MONTGOMERY COUNTY HISTORIC PRESERVATION COMMISSION
STAFF REPORT

Address:	10304 Montgomery Avenue, Kensington	Meeting Date:	9/3/2025
Resource:	Primary Resource Kensington Historic District	Report Date:	8/27/2025
Applicant:	Jeff and Gloria Capron (Luke Olson, Architect)	Public Notice:	8/20/2025
Review:	Historic Area Work Permit	Tax Credit:	No
Permit No.:	1060765 REVISION	Staff:	Laura DiPasquale
Proposal :	Revisions to previously-approved rear deck

Figure 5: Currently-proposed rear elevation.

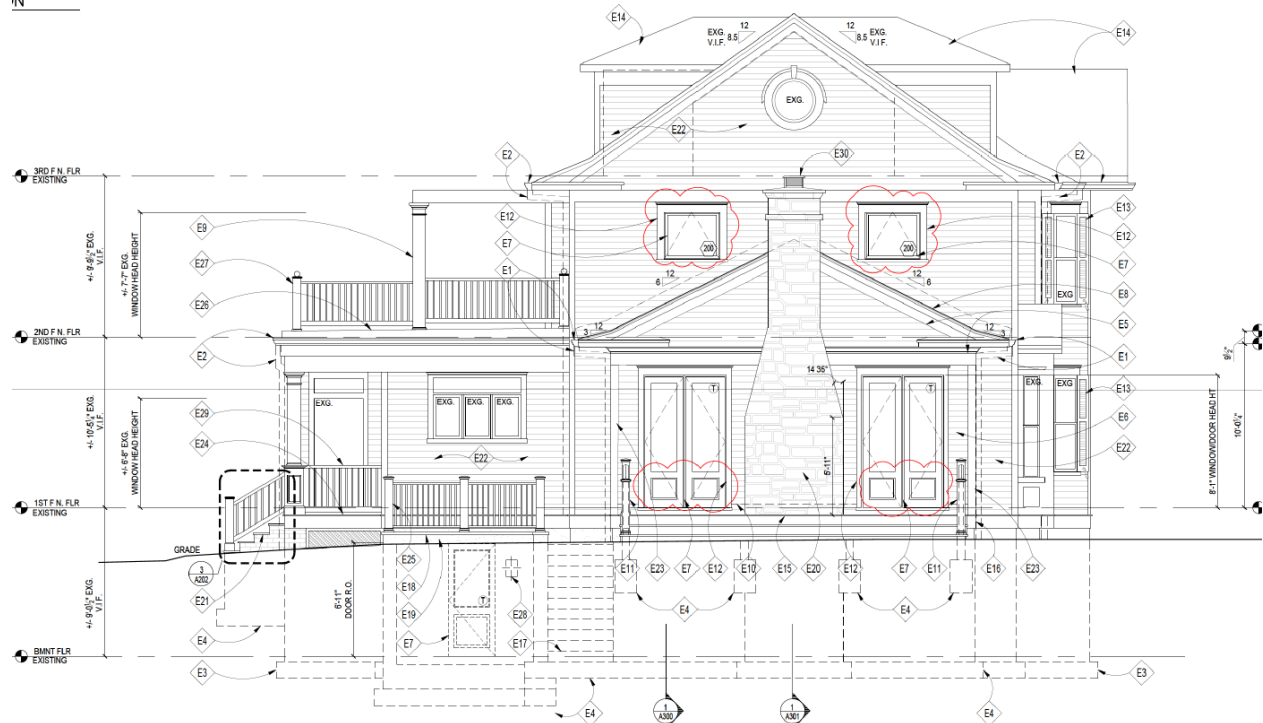
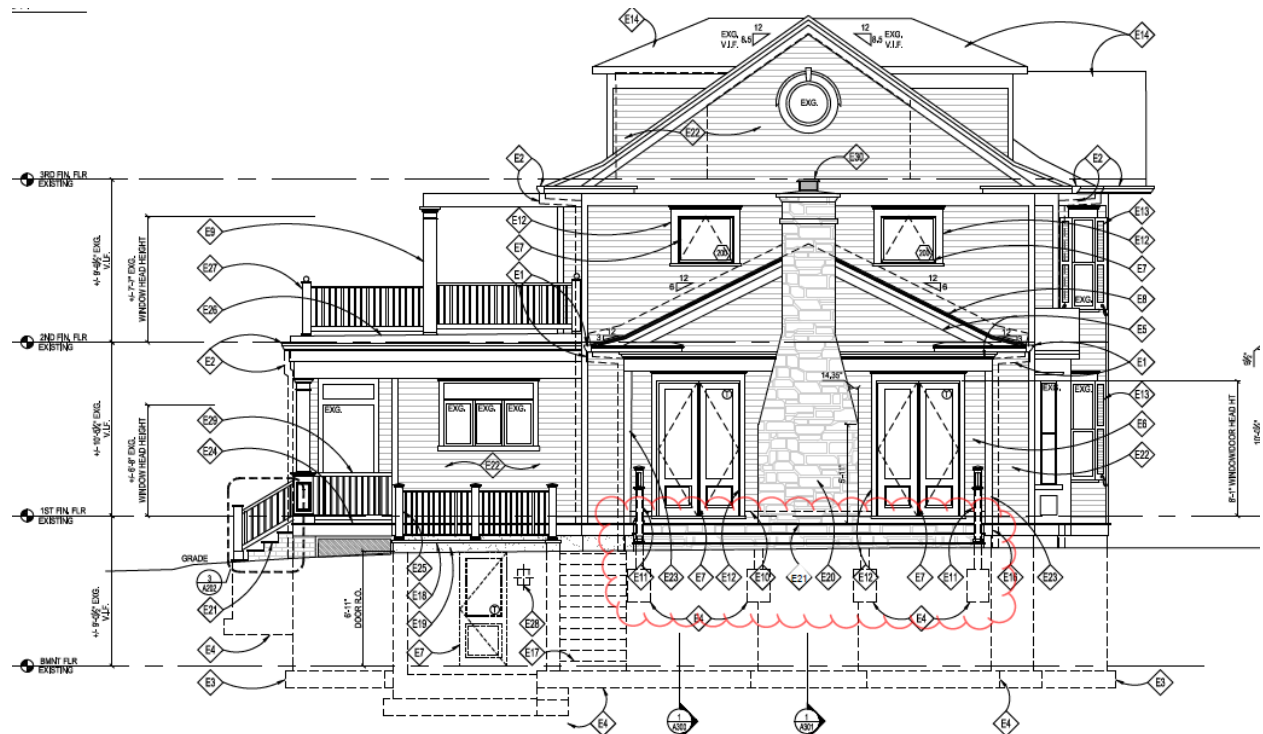
The applicant proposes to change the previously-approved wood-frame rear deck with composite decking to a poured concrete porch clad in stone with flagstone decking. No changes are proposed to the footprint of the deck or the railing.

Staff supports the proposed material changes for the proposed rear deck and recommends approval. Staff finds this revision is a de minimis change that will not impact the massing of the proposed addition or the character of the house or surrounding district, per Chapter 24A-8(b)(1). Staff finds that, as a Primary resource, *Policy No. 24-01* allows for case-by-case evaluation of the appropriate porch and deck material on a building addition. Staff finds that the HPC previously approved construction of the new rear deck with compatible substitute materials—Azek and Aeratis. Staff finds that the change to a poured concrete structure clad with stone risers, cheek walls, and flagstone decking, is compatible with the resource and district for use on a non-historic rear addition. Staff finds these changes will be minimally visible or invisible from the public right-of-way, will not impact the historic fabric or the historic character of the house and will be compatible with the resource and district, per Chapter 24A-8(b)(2) and *Standards 2* and *9*.

Staff recommends that the Commission **approve** the revisions to this HAWP application under the Criteria for Issuance in Chapter 24A-8(b)(1) and (2), having found that the proposal is consistent with the *Vision of Kensington*, and therefore will not substantially alter the exterior features of the historic resource and is compatible in character with the district and the purposes of Chapter 24A;

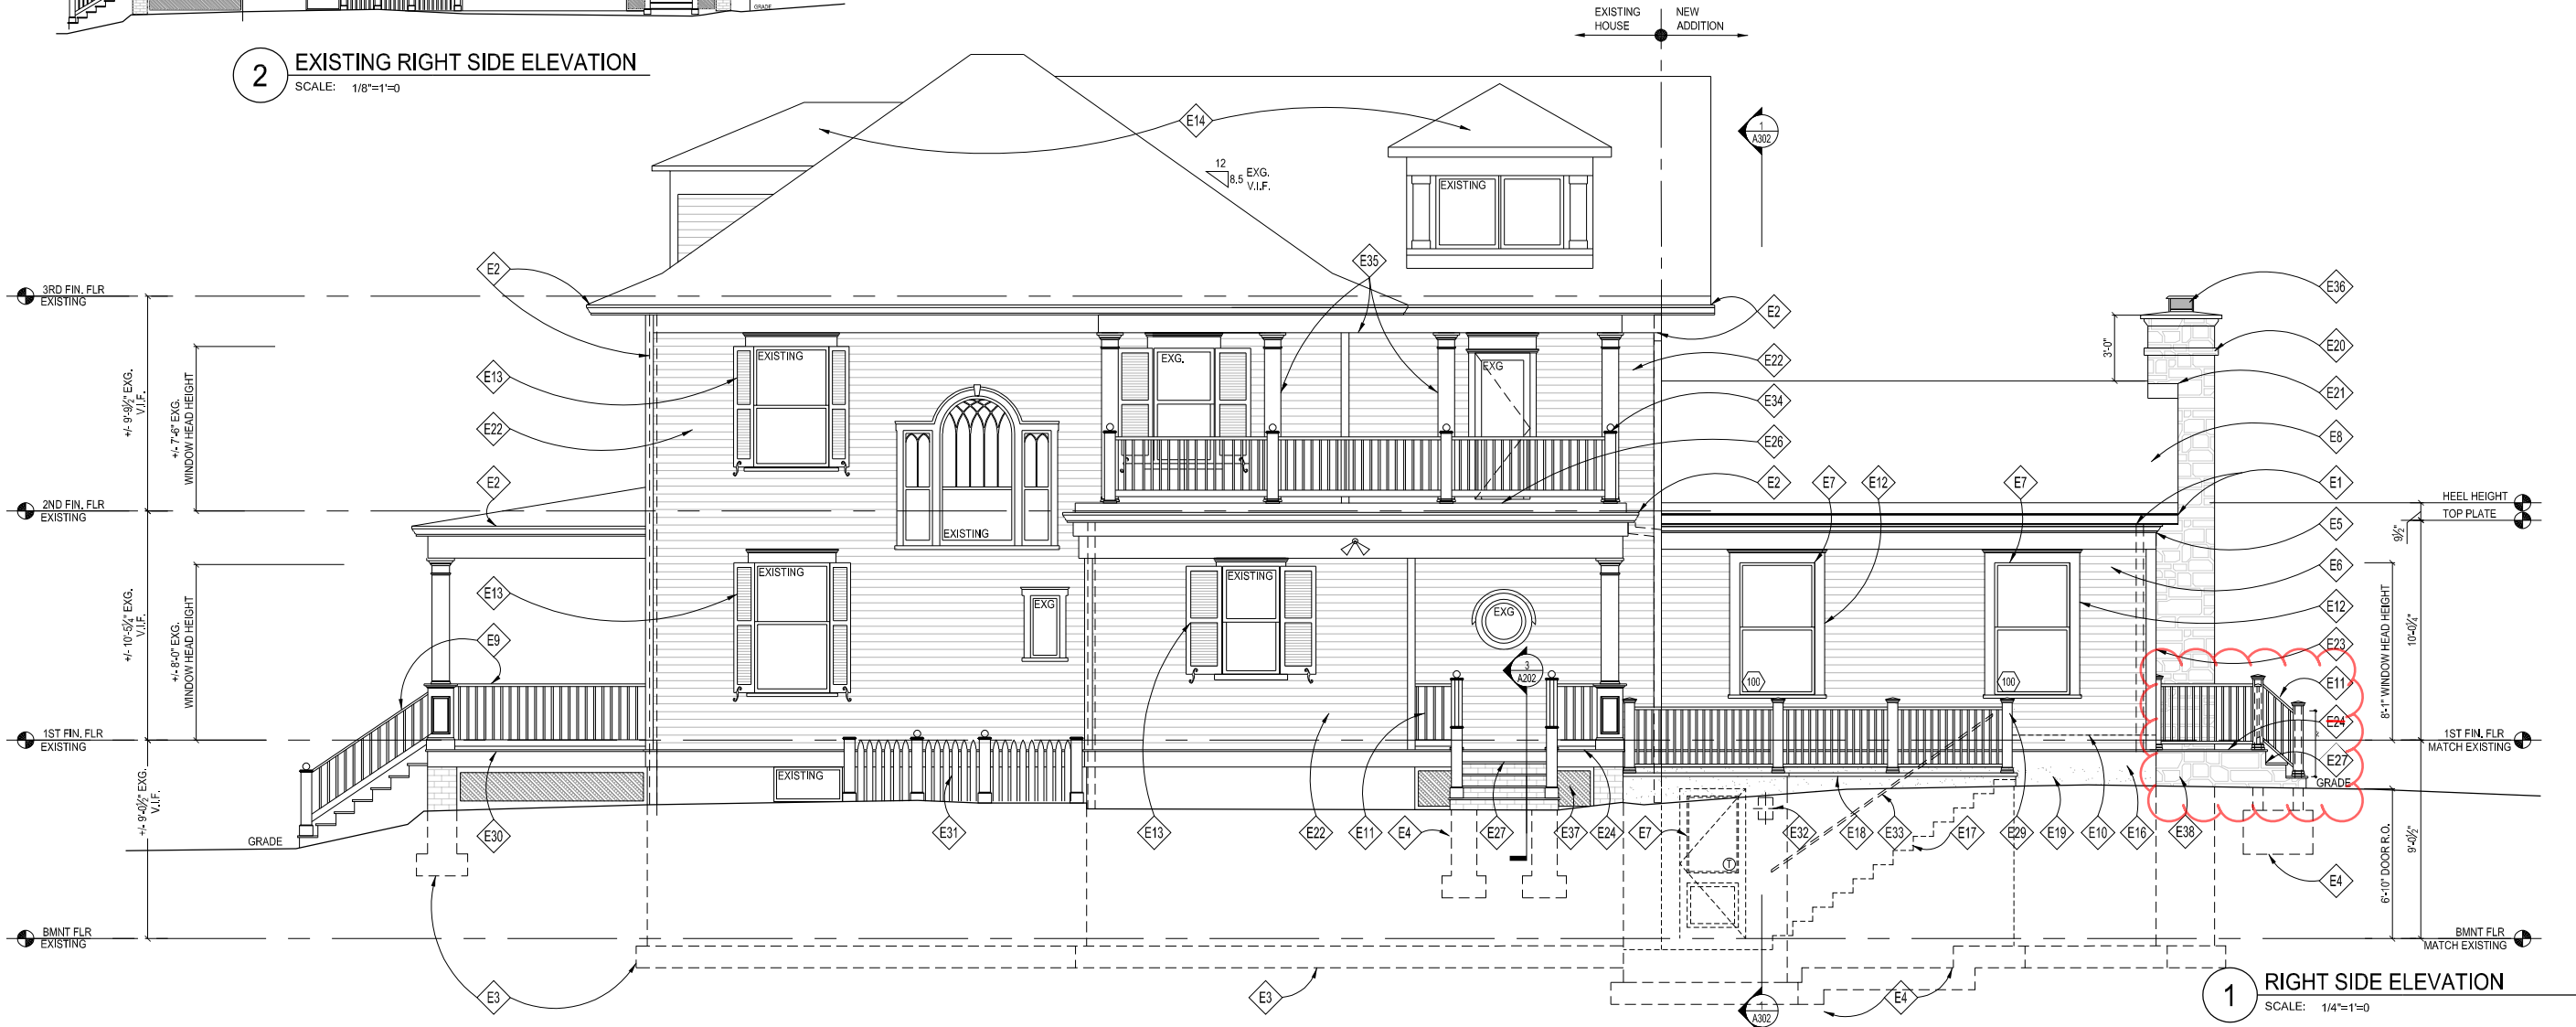
We have previously received approval for our Historic Area Work Permit application. We would like to make a revision to change the rear porch from a wood-frame porch with composite decking to a poured conc. porch clad in stone with flagstone decking.
